**CITY OF DULUTH**
Planning Division

# STAFF REPORT

| **File Number** | PL 14-152 | **Contact** | Jenn Reed Moses, jmoses@duluthmn.gov | | |

Replace the existing generator building structure with a new 43' x 95' generator building that will house up to 5 generators and 2 fuel tanks.

LANDSCAPE PLAN

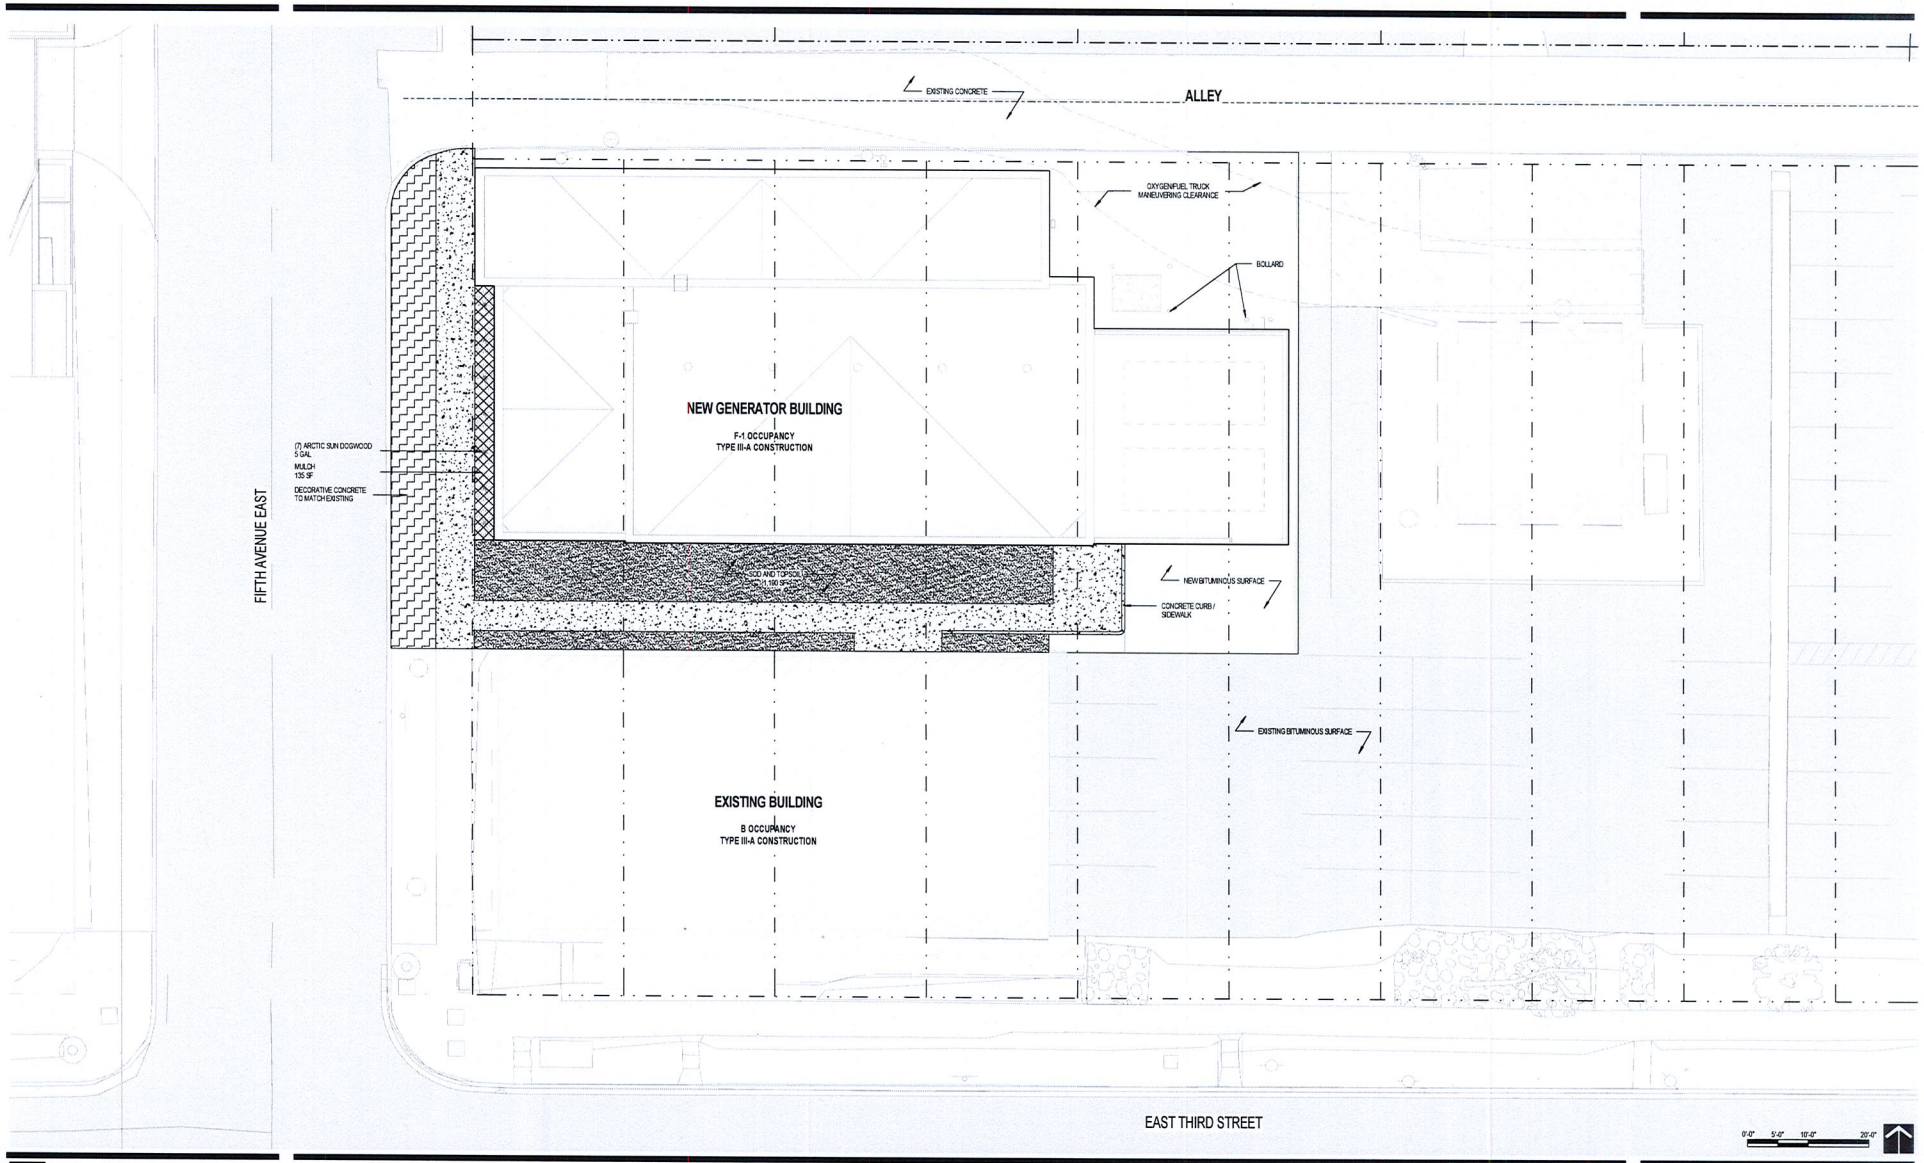
4.) 50-25 (Landscaping) - As the building is less than 10,000 sq ft, no landscaping is required. Project will provide shrubs along the west building facade adjacent to the street.

EXTERIOR ELEVATIONS

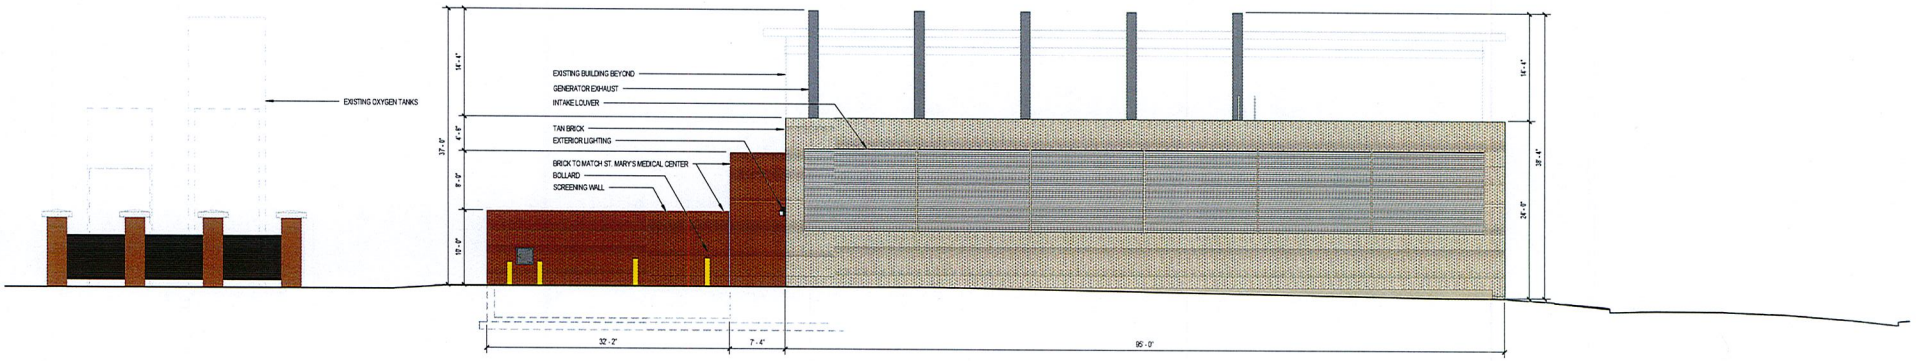
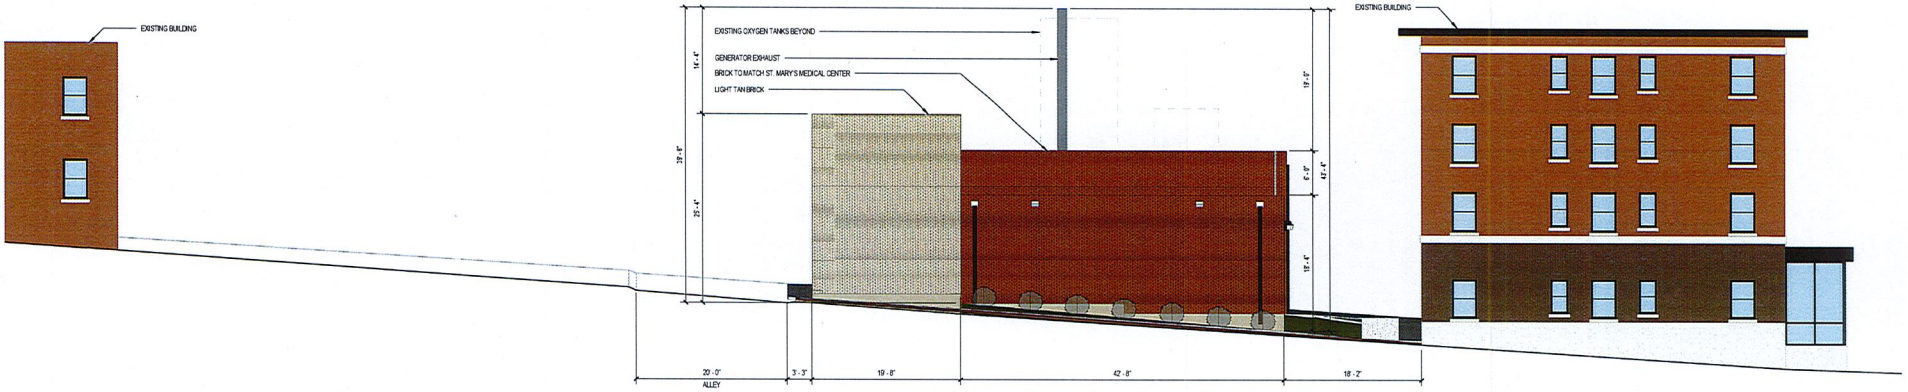
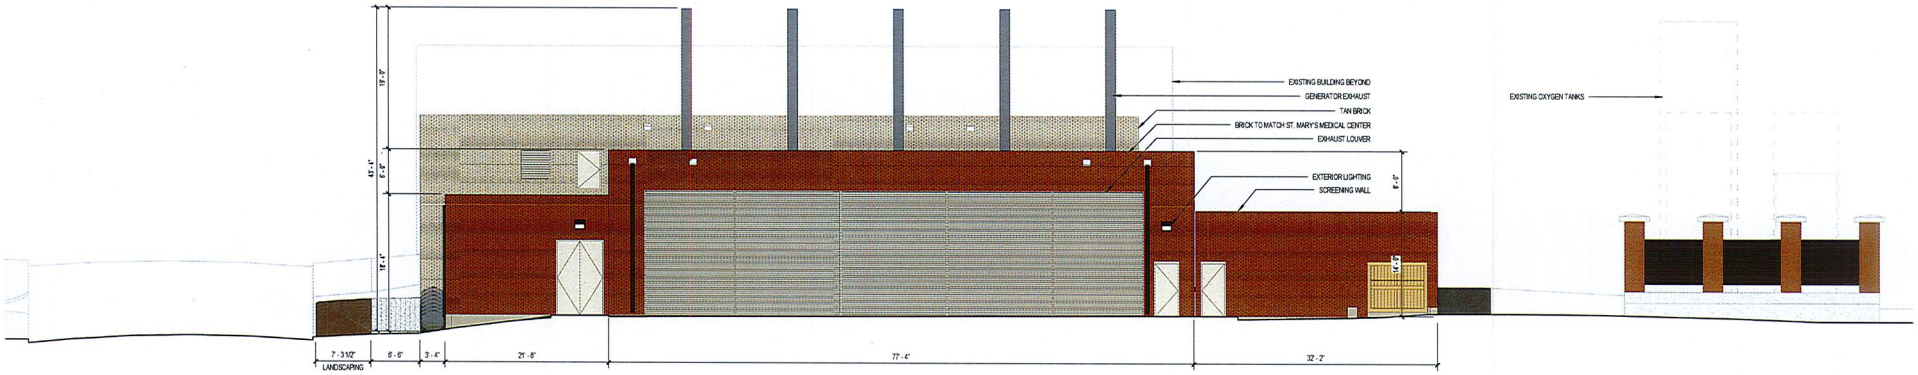
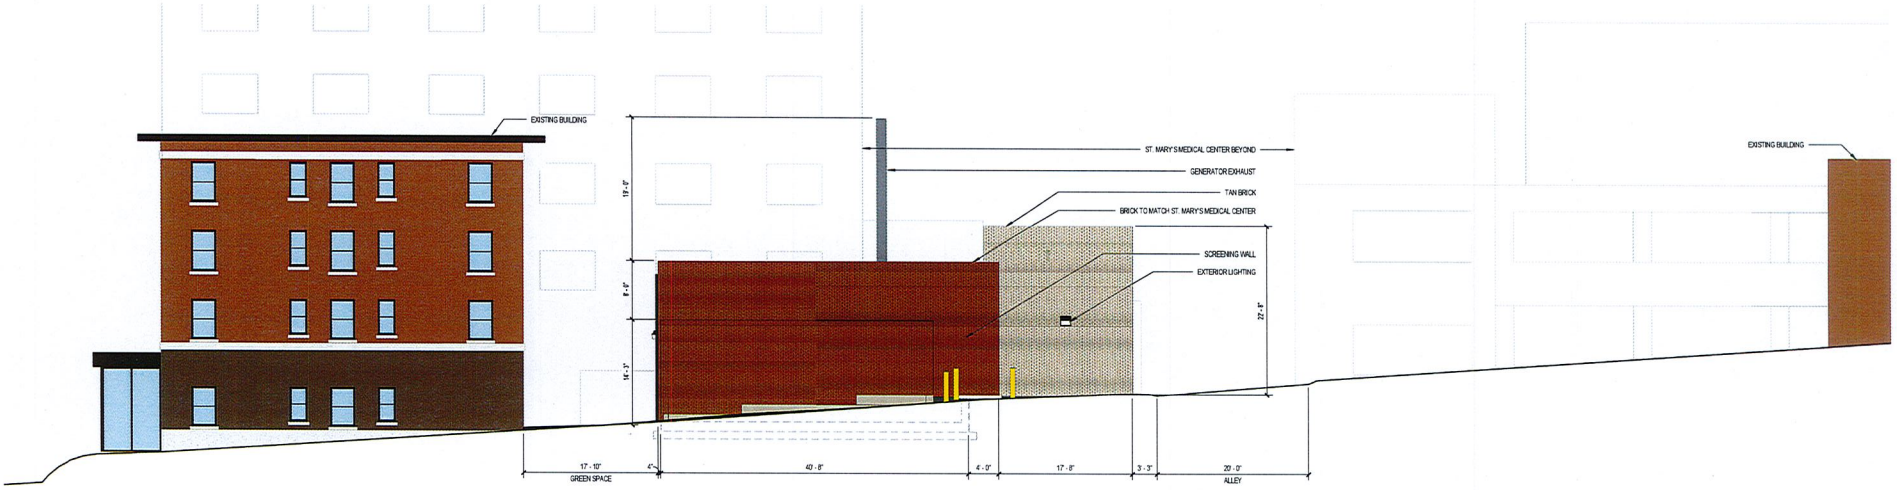
7.) 50-30 (Design Standards) - Building design standards do not apply. Per the request of Staff, applicant has changed building massing and provided two exterior finishes, as well as provided landscaping as mentioned above, to improve the aesthetics of the building.

SHEET TITLE :
**PRELIMINARY SITE LIGHITNG PHOTOMETRICS**

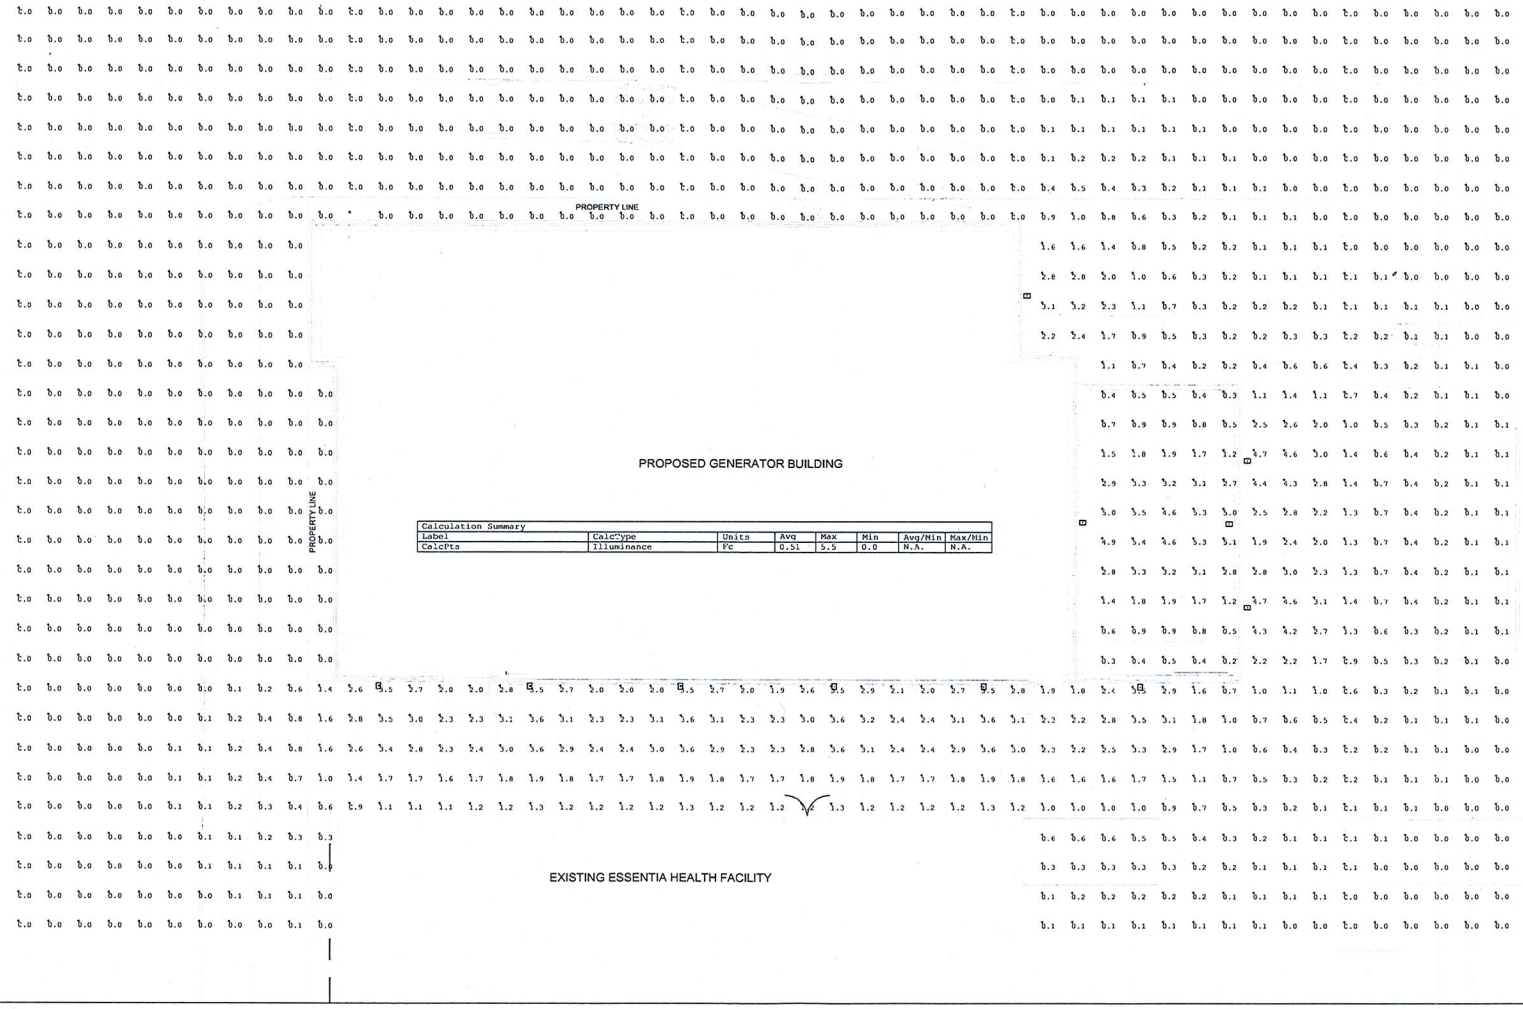
8.) 50-31 (Exterior Lighting) - Proposed lighting includes full cut-off fixtures attached to the building wall.
9.) 50-34 (Maintenance and Operating Standards) - All activities must comply with state statutes and regulations. Before receiving a building permit, documentation should be provided showing that the building will suppress noise of generators to an acceptable threshold.
